Errata Sheet

October 16, 2001 / Release 1.5

Device: **SAK-C167CS-LM**
 SAK-C167CS-4RM

Stepping Code / Marking: **ES-AB, AB**

New value of the PLL jitter

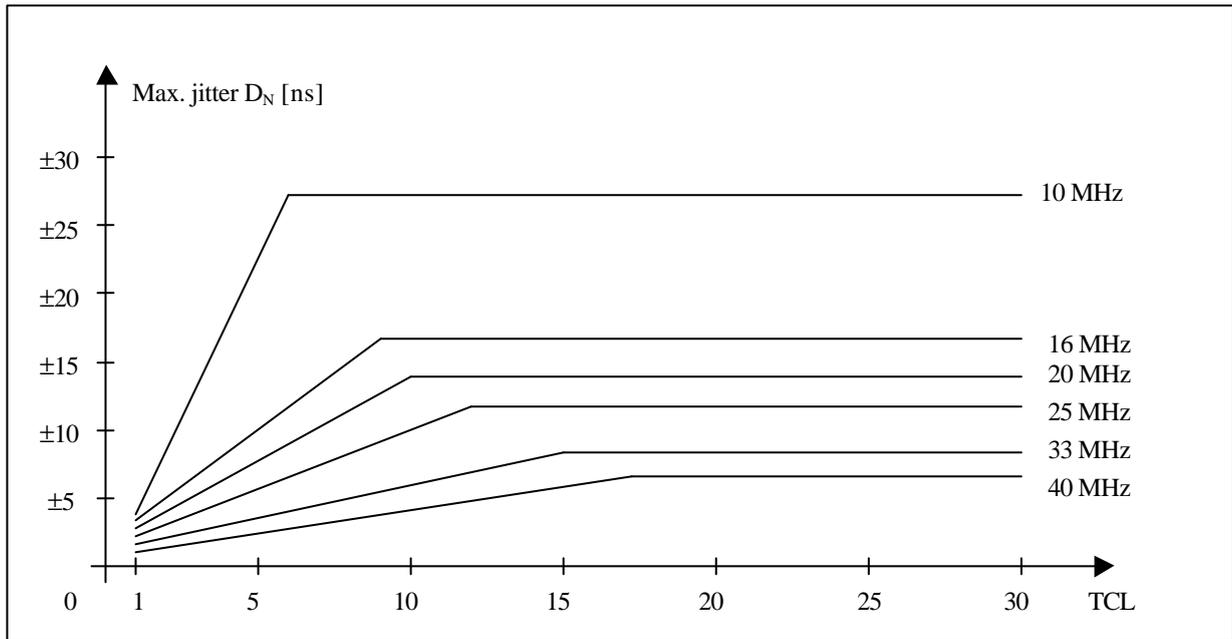
In systems where the PLL is used for generation of the CPU clock frequency, the PLL jitter can increase under certain circumstances and exceed the specified value.

The value of the additional jitter is not a fixed one but it depends on the kind of activity on the external bus or output pins. The additional jitter increases with the number of output/bus pins which are switched at the same time to a new voltage level because the problem is caused by noise on the on-chip power supply.

The additional jitter has the maximum effect if only one TCL is considered (period jitter). This can have an influence to the bus timings with one TCL.

The additional jitter decreases with the number of consecutive TCLs (accumulated jitter). The accumulated jitter has an effect on timings with more than one TCL (certain bus timings, CAN bus timing, serial interface).

For an accumulated period of $N \cdot \text{TCL}$ the new maximum jitter $D_N[\text{ns}]$, which exceeds the specified value in the Data Sheet, is computed using the formula:

$$D_N[\text{ns}] = \pm((260 / f_{\text{CPU}} + 100 / f_{\text{CPU}}^2) * (N / T_m) + 0.2)$$

Were N = number of consecutive TCL, f_{CPU} = CPU frequency in MHz and $T_m = f_{\text{CPU}} * 0.35 + 2.5$. This approximated formula is valid for a CPU frequency $10 \text{ MHz} \leq f_{\text{CPU}} \leq 40 \text{ MHz}$ with the conditions:
